Addendum No. 1
To The Invitation for Bids

Contract: **OB-144A**

Description: **TRC Optimization at the Oakwood Beach Wastewater Resource Recovery Facility**

Addendum No. 1:

Attachment #1: Revised Contract Drawing E-001.01

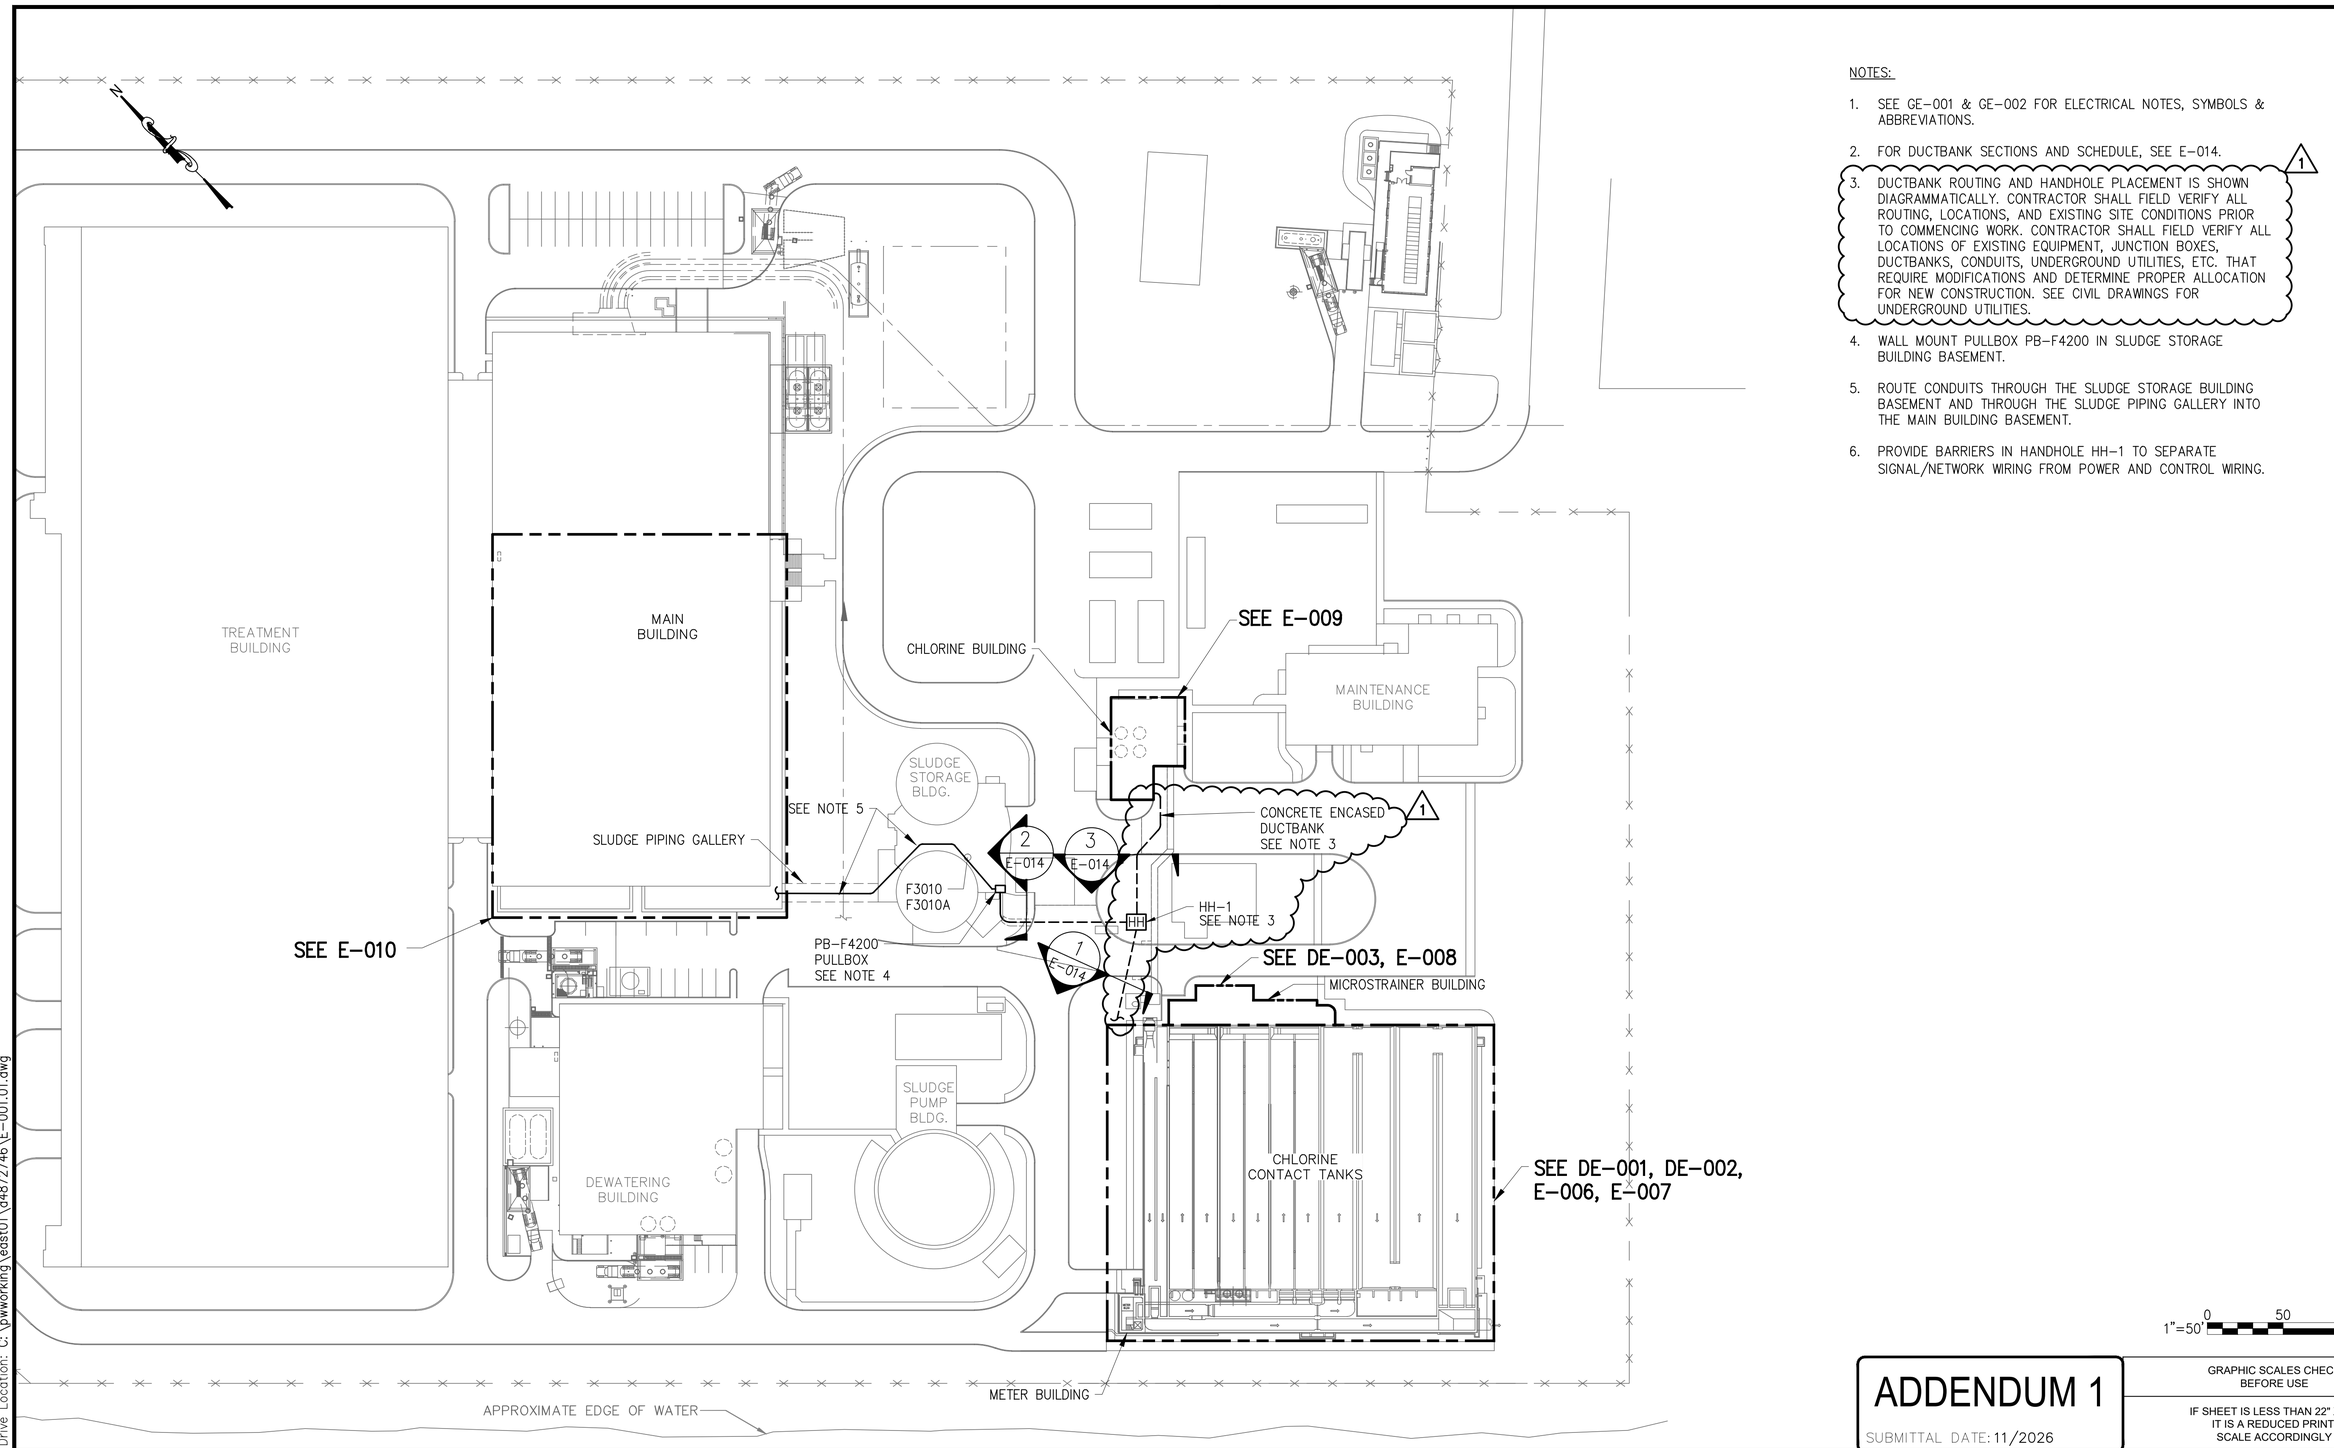
4. Sheet E-001, General Note 3, **DELETE** in its entirety and **REPLACE WITH** "Ductbank routing and handhole placement is shown diagrammatically. Contractor shall field verify all routing, locations, and existing site conditions prior to commencing work. Contractor shall field verify all locations of existing equipment, junction boxes, ductbanks, conduits, underground utilities, etc. that require modifications and determine proper allocation for new construction. See civil drawings for underground utilities."

2) Question – Please reference Drawing E-001.00 in where the proposed electrical ductbank and handhole go directly through a temporary office trailer complex. Please confirm the office trailer will be removed prior to the mobilization of the project.

Response – Office trailers will NOT be removed. The proposed electrical ductbank and handhole locations can be relocated and shall be coordinated with DEP prior to work. This clarification is included in this Addendum.

Attachment #3: As-Built Drawing E-101 from Contract OB-29 (1970)

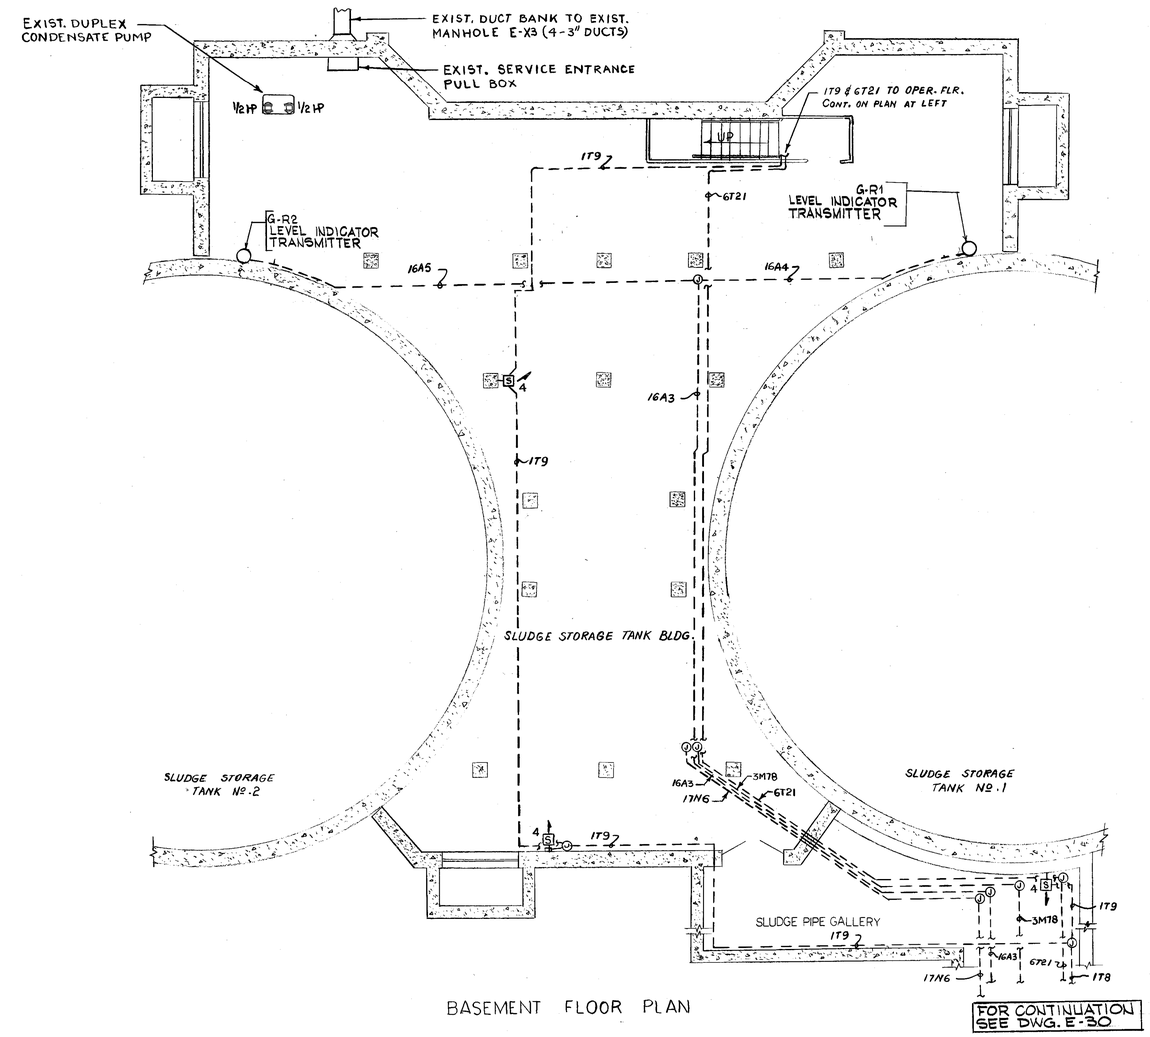
3) Question – Please reference Drawing E-001.00 in where the proposed electrical ductbank is to be routed to and through the Sludge Storage Building basement. Please provide as-builts of the Sludge Storage Building basement and foundation.

Response – As-built drawing (E-101 from Contract OB-29 (1970) is included as Attachment #3 to this Addendum.
